PLANNING BOARD

i. Major Site Plan and Traffic Movement Permit; 385 Congress Street; Portland Music Holdings, LLC, Applicant. The Planning Board will hold a hybrid workshop to consider a major site plan and traffic movement permit application to facilitate the development of a 65,340 square foot entertainment venue with capacity for up to 3,310 patrons, which would also include food and beverage services, administrative offices, and indoor and outdoor lounge area, and back-of-house operations areas. The subject property is located downtown, and is within the B-3 Downtown Business zone. A project and plan summary are available for viewing on the city's CSS Portal (<https://css.portlandmaine.gov/>) by referencing Plan Number PL-003179-2024.

To: Chair Brandon Mazer & Members of the Planning Board
From: Taylor Colbeth
Date: March 21, 2025
Re: 385 Congress Street – Live Nation Music Venue
Project ID: PL-003197-2024
CBL: 027 D003
Meeting Date: March 25, 2025

C-100

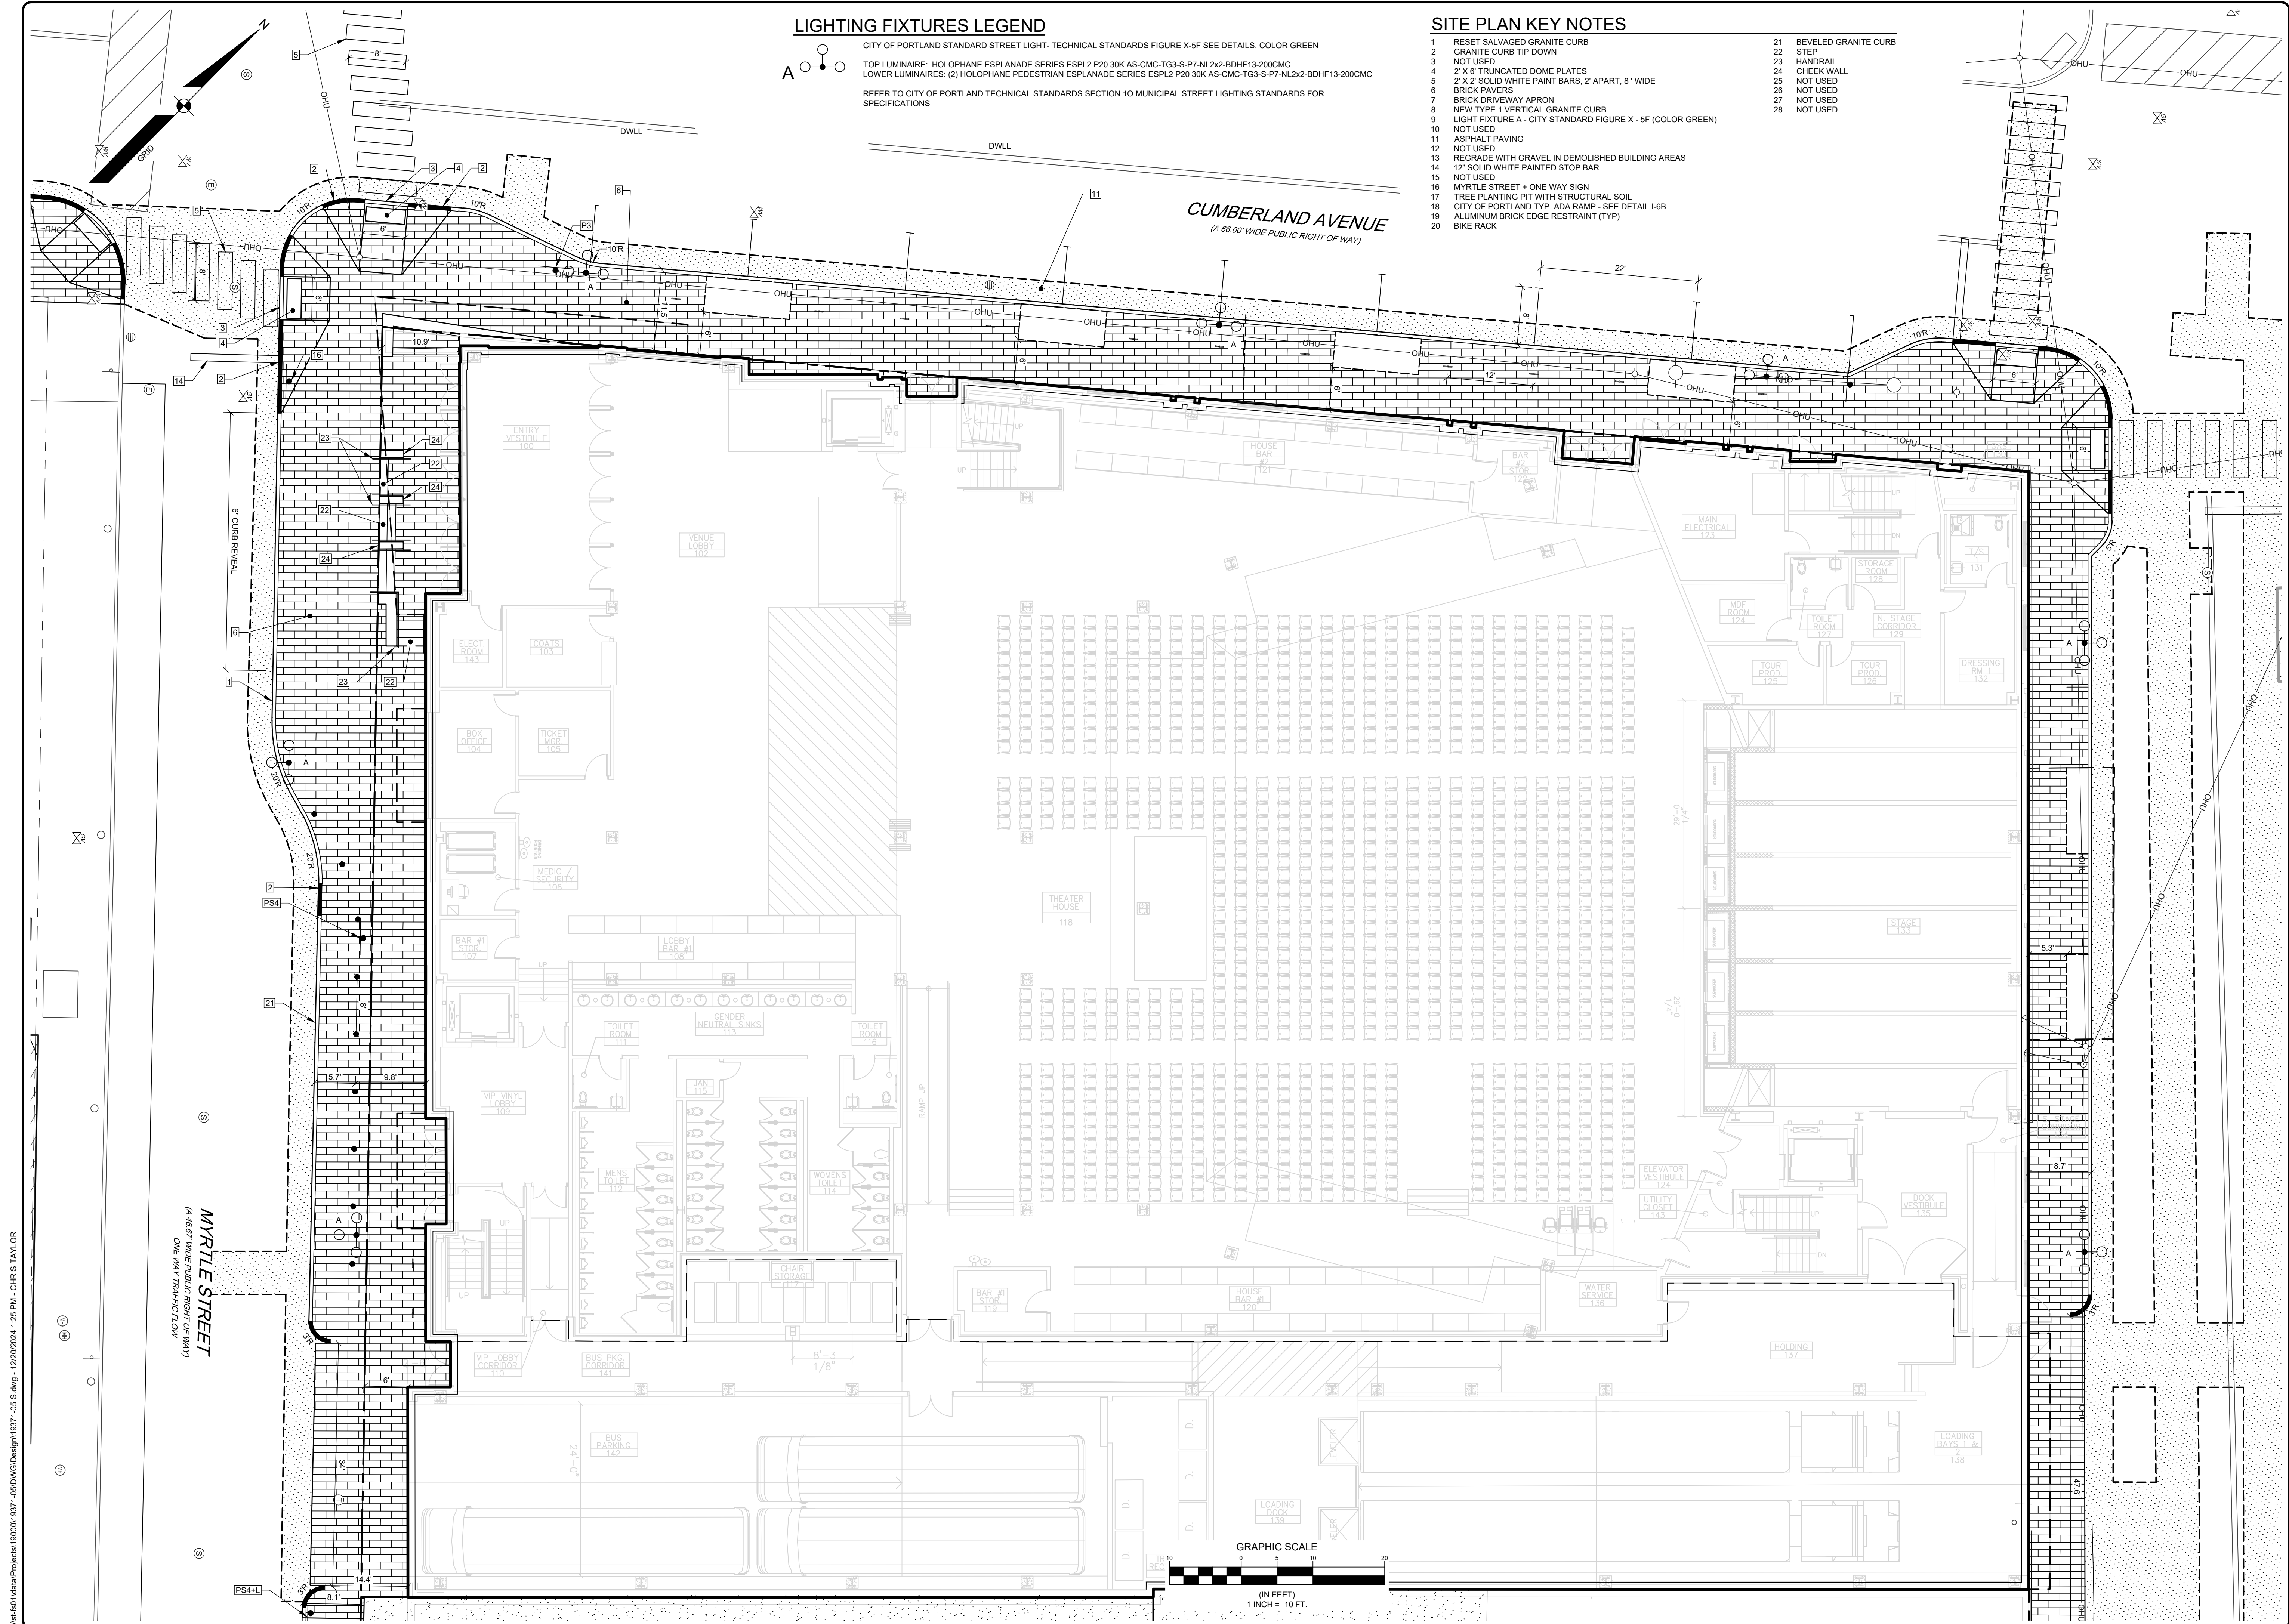
- City staff recommends that the applicant remove the proposed bollards and mountable curb and revise the design to incorporate granite curbing that runs coterminous with where the bollards were proposed to accommodate an additional loading area. Additionally, an easement or license agreement for the sidewalk on private property must be completed before a building permit is issued.

- Staff recommends that the applicant ensure bike racks along Myrtle Street and Cumberland Avenue do not reduce the sidewalk width when bikes are parked.
- Due to the loss of existing metered parking spaces on Myrtle Street, the applicant must provide an equivalent or greater number of on-street metered parking spaces along Cumberland Avenue. To compensate for the reduction of sidewalk space within the public right-of-way on Myrtle Street to accommodate an additional loading area, City staff recommend shifting the building's Pearl Street façade back by a minimum of approximately 5 feet from the property line. This adjustment to the building along Pearl Street would allow for the creation of an extended publicly accessible sidewalk as well as additional on-street parking spaces and/or a loading area along Pearl Street between Cumberland Avenue and loading bays 1 and 2.

UTILITY PLAN KEY NOTES

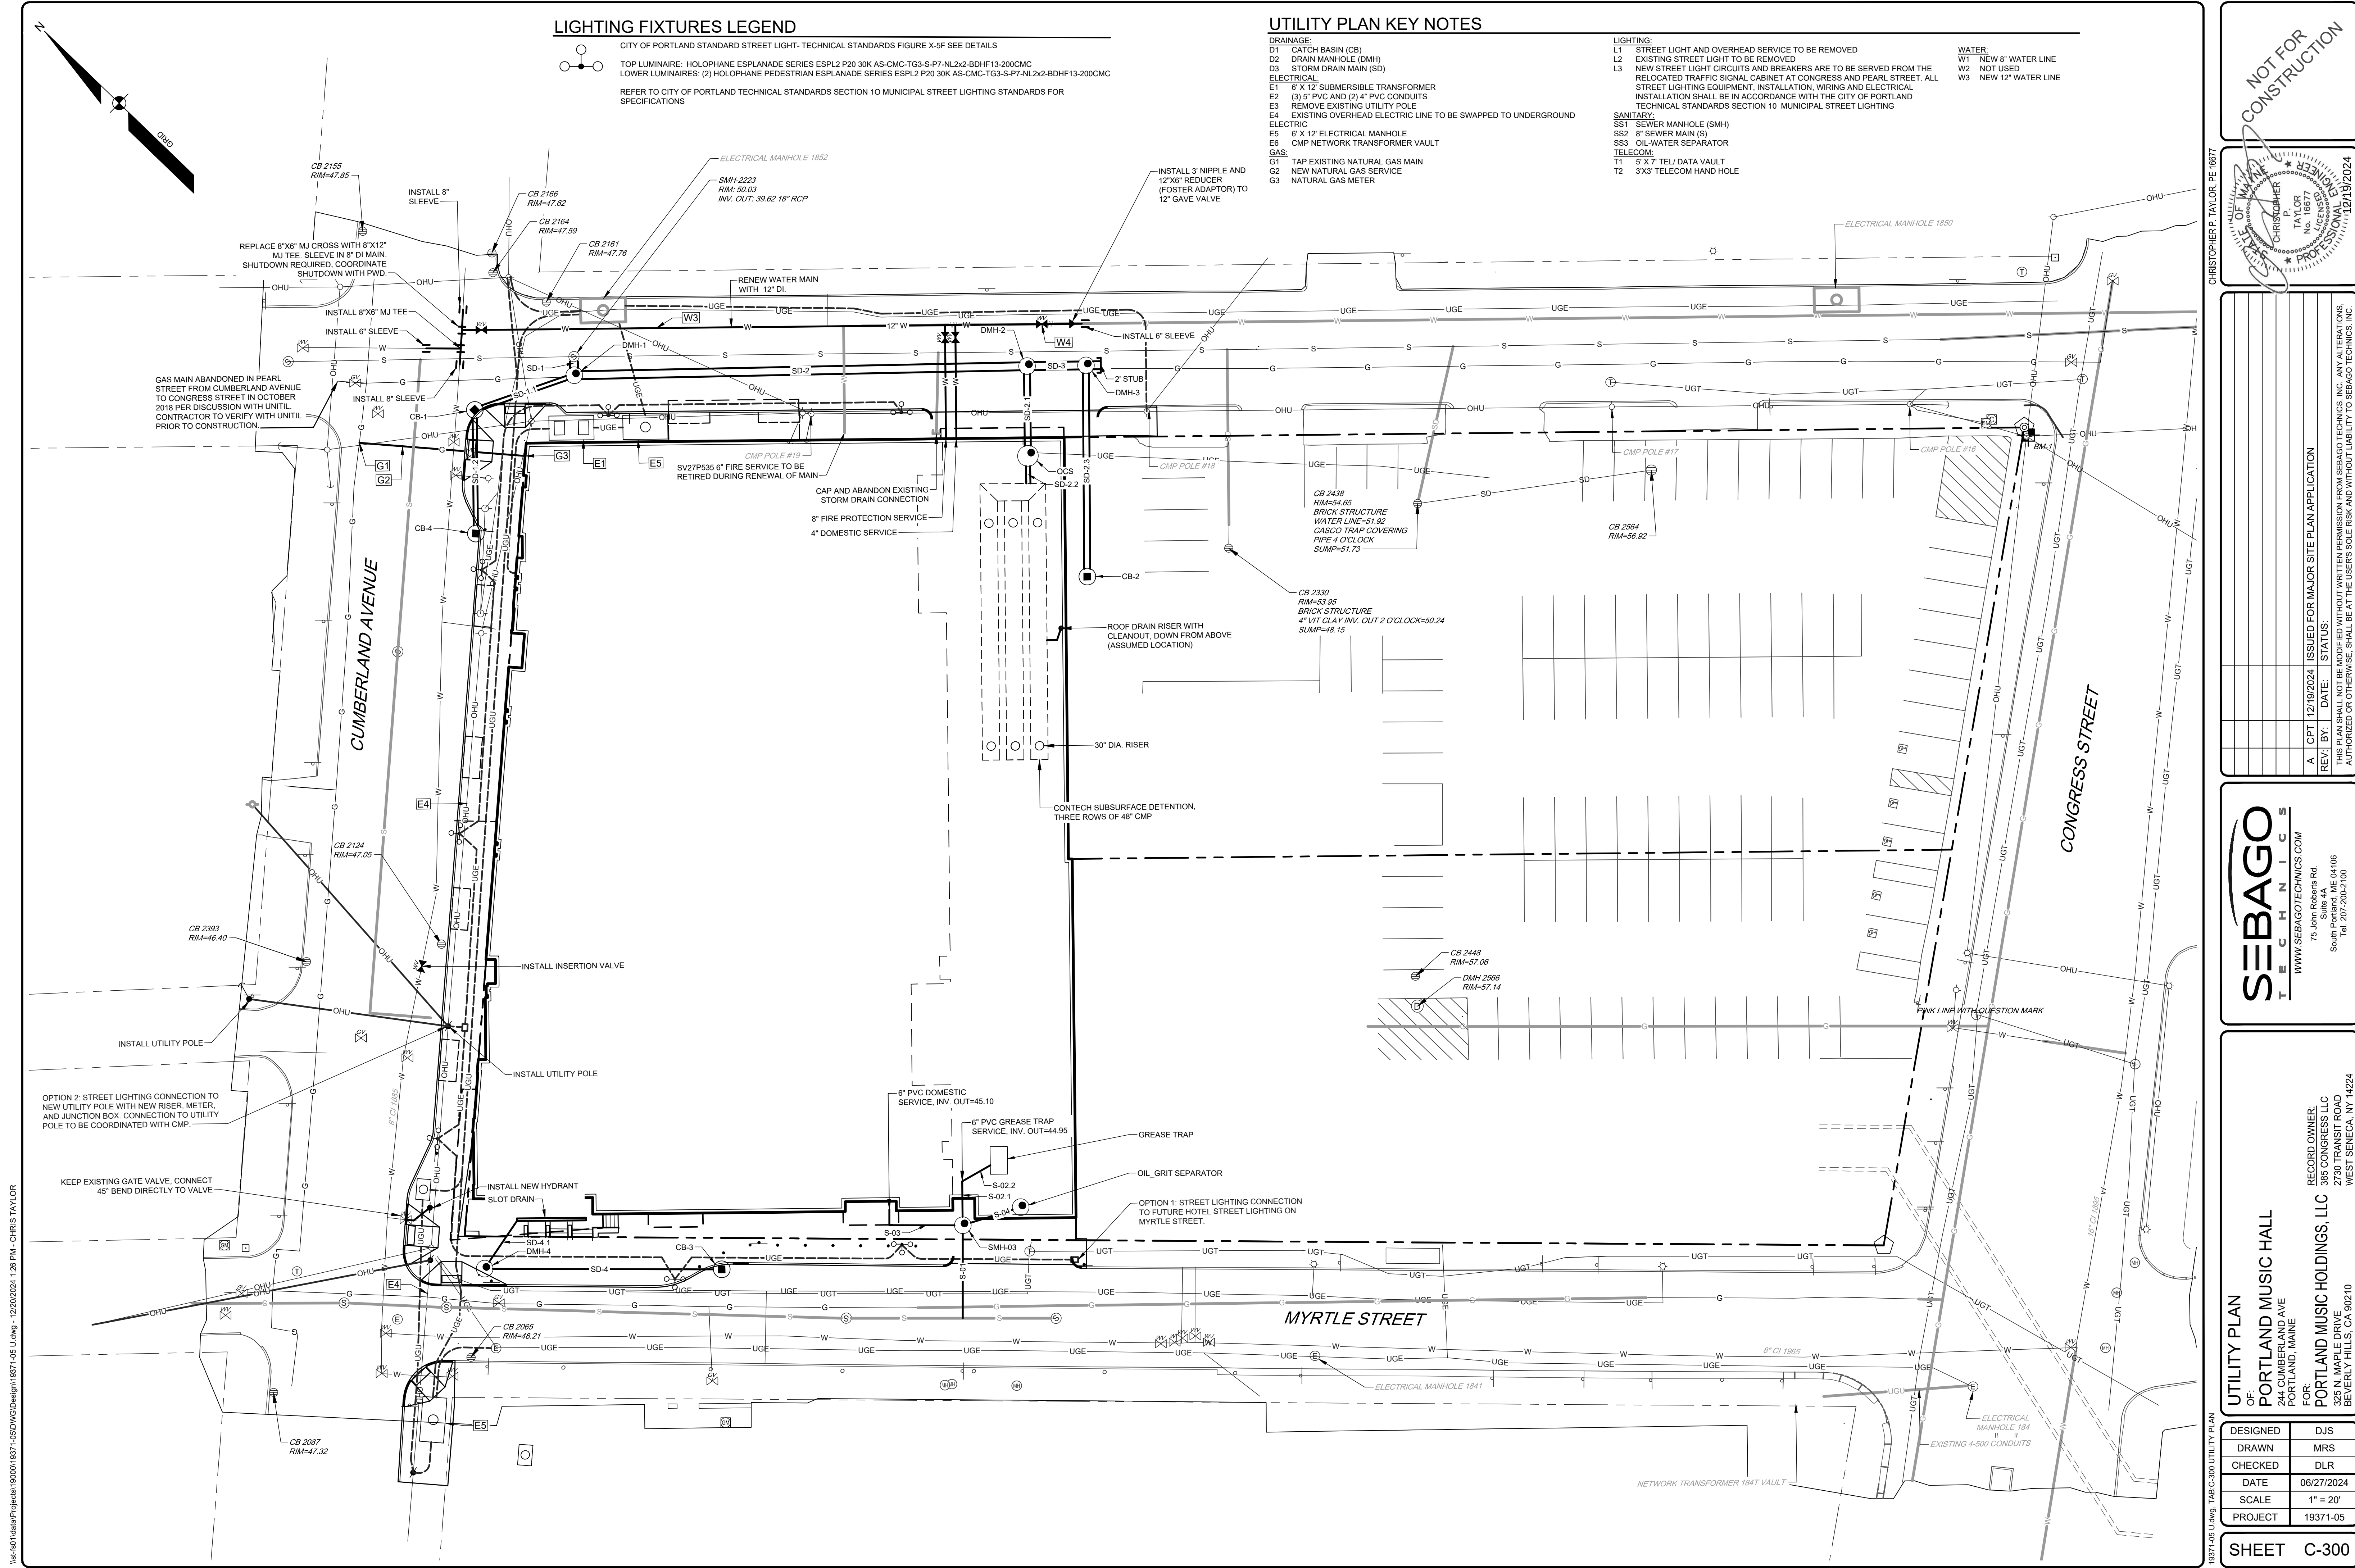
- Staff have requested revisions to the utility plan and clarification on the electrical layout.
- The applicant shall submit an ability to serve confirmation from the Portland Water District once received.
